California Flats Solar Project

Final Environmental Impact Report

December 2014

Figure 4.4-9
County of Monterey

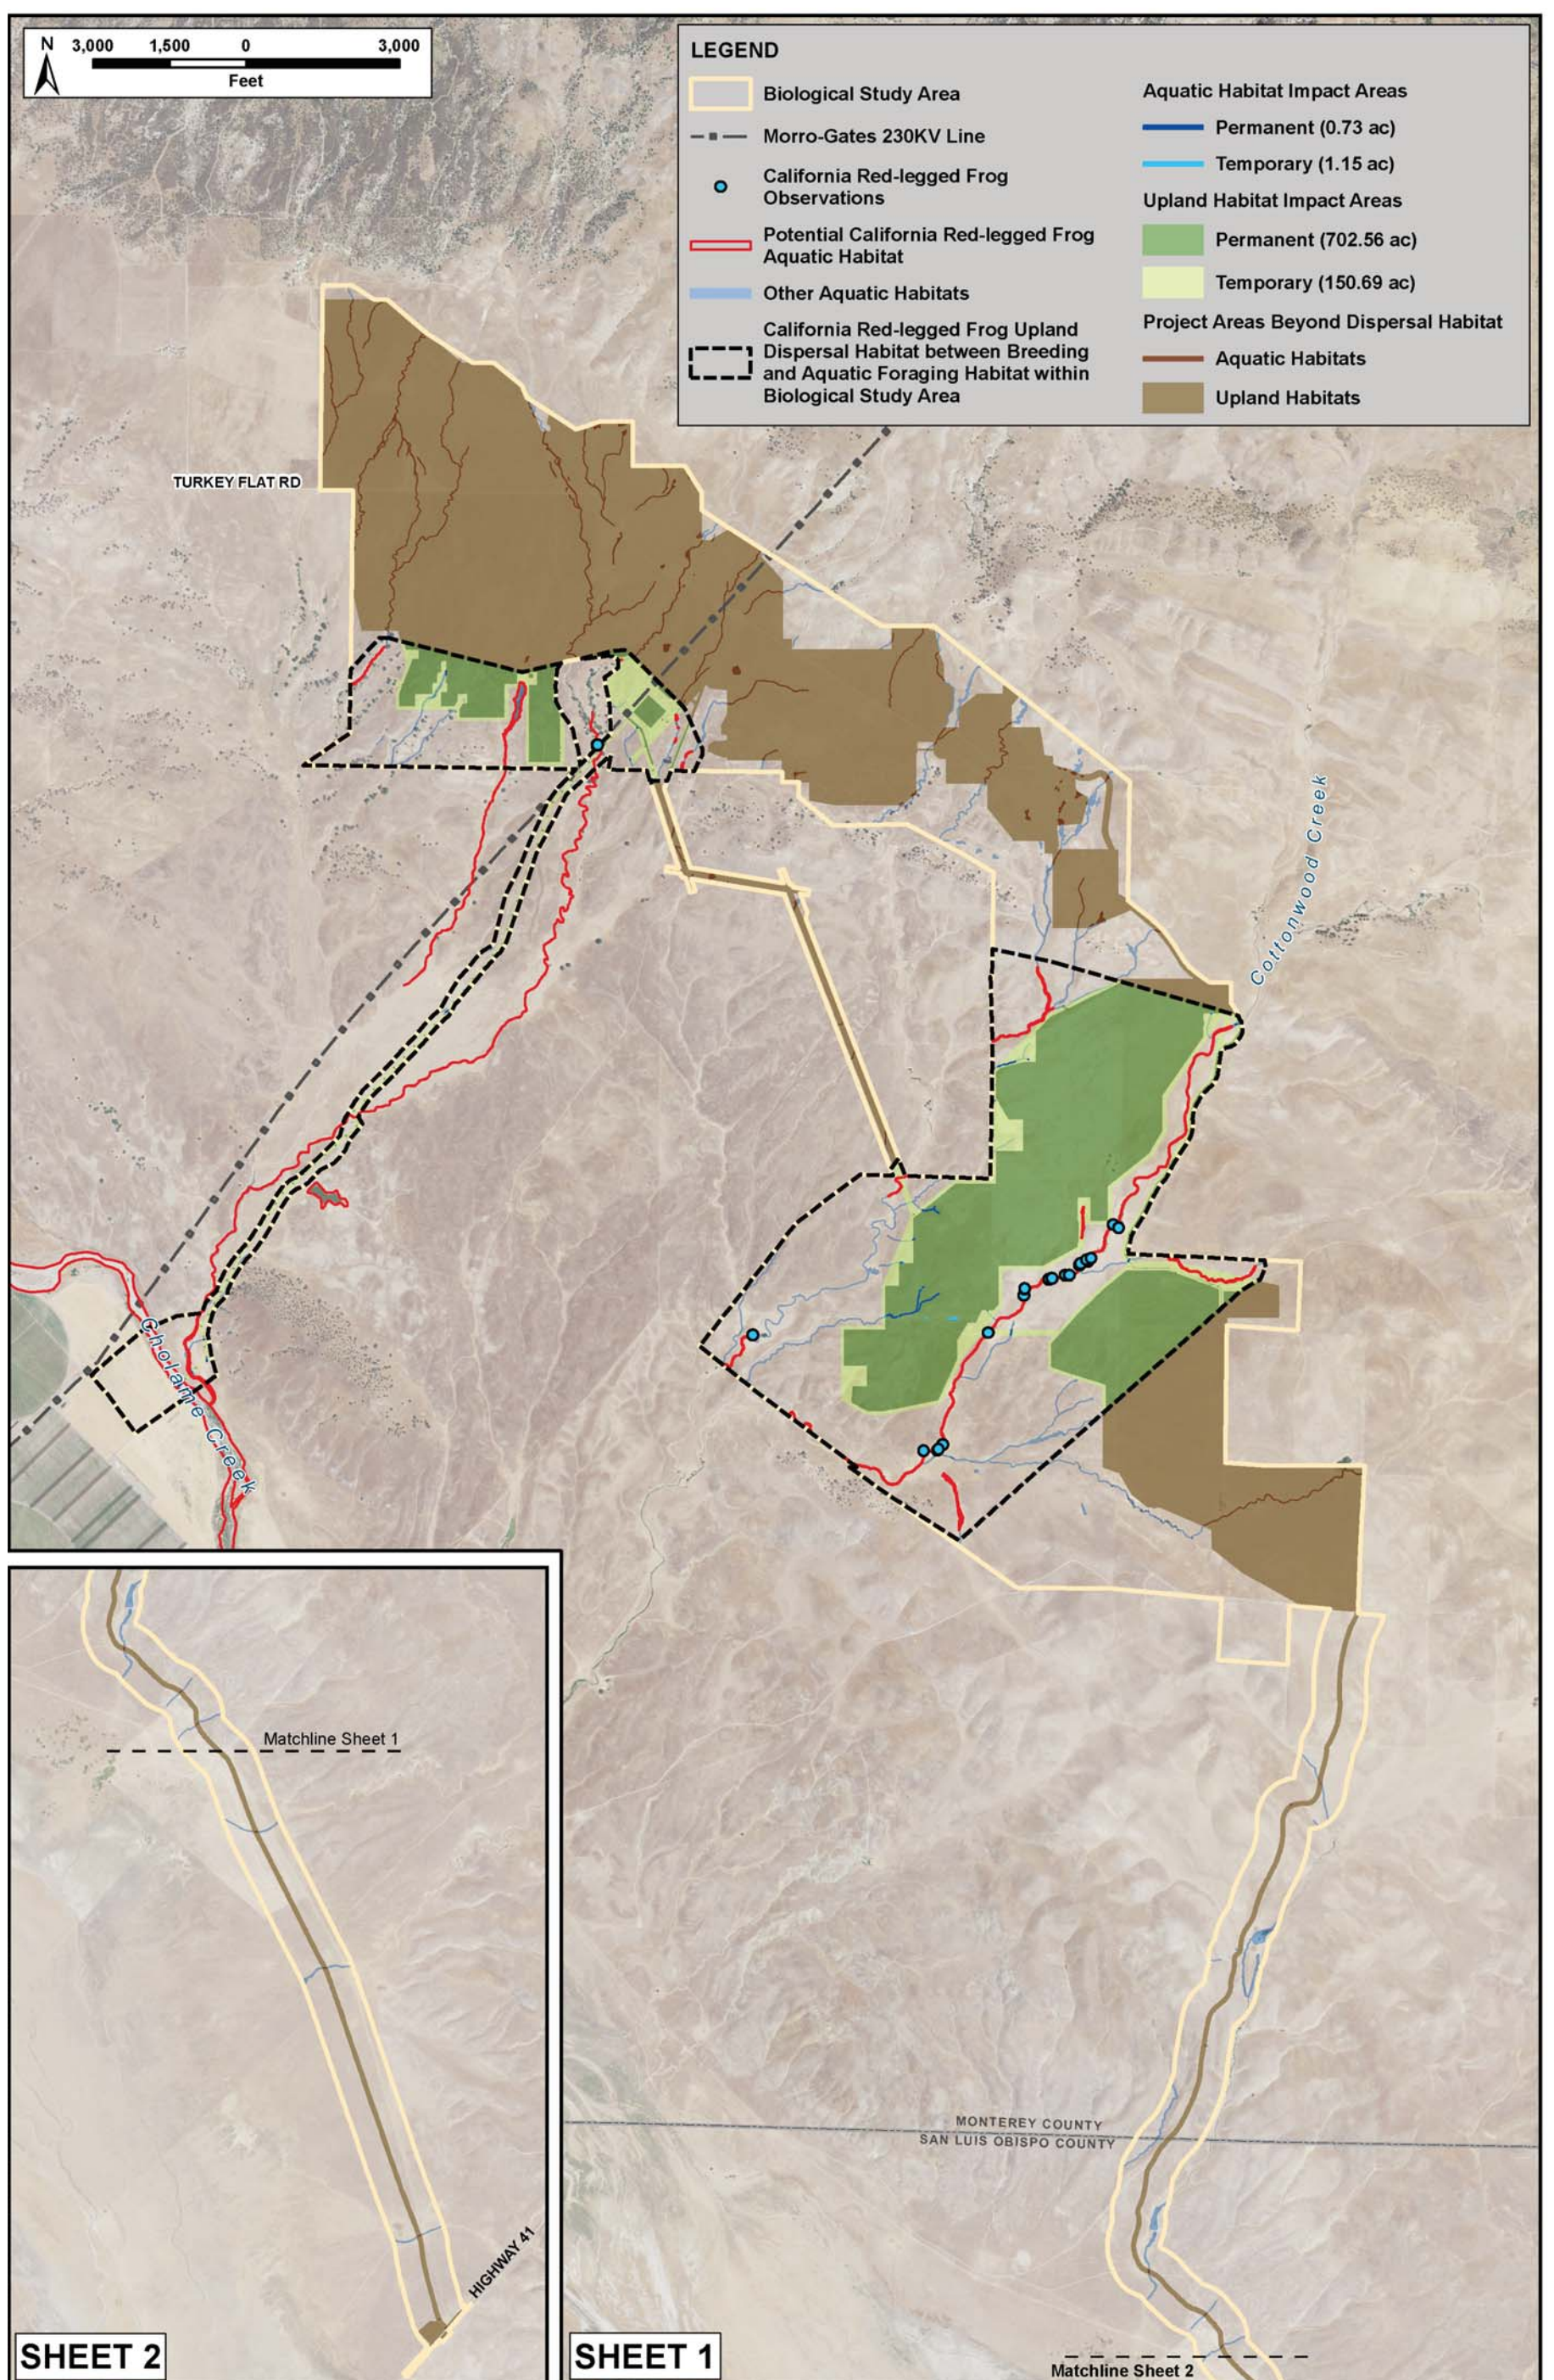
26.	Section 4.4 (Biology)	4.4-101 & 4.4-109 to 4-14	FIGURES 4.4-8 to 4-11	Element Power is incorrectly attributed as the source for Figures 4.4-8 to 4.4-11. Please revise each of these figures to correct the attribution as follows: “Source: Amy Sparks (H.T. Harvey & Associates) and First Solar, 2014”.	16.182

Figures 4.4-9 through 4.4-11; revisions shown on the following pages.
